# Access Compliance Report

## Public Rights-of-Way

| Intersection ID: 31876                  | Main Street: ARABELLA_DR | Cross Street: WILLIAMS_GLENN_RD         | Location: NW           |
| ADA ID: EC4D8B99A1EA                    | Ramp Type: PerpDiag      | Initial Pass/Fail: Fail                 | Overall Compliance: No |

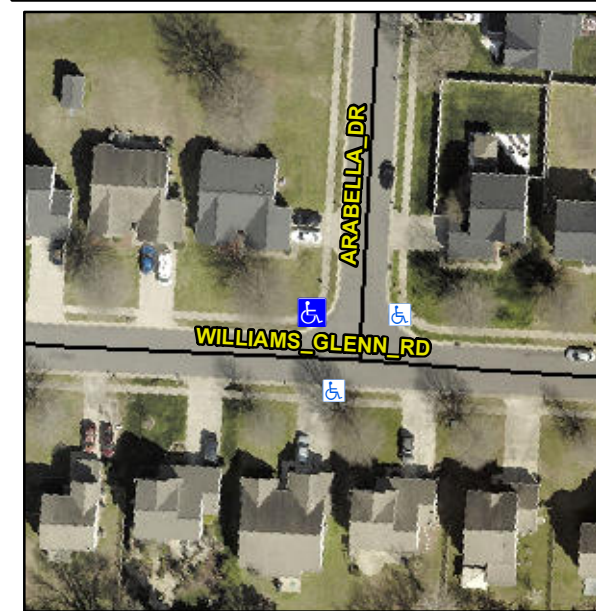
**R304.5.3**

| Compliance | Description           | Data | Compliance | Description                 | Data |
|------------|-----------------------|------|------------|-----------------------------|------|
| Yes        | Ramp Width (in)       | 48.0 | No         | Ramp XSlope (%)             | 8.3  |

**Remove & Replace Curb Ramp With Two New Directional Ramps or Equivalent.**
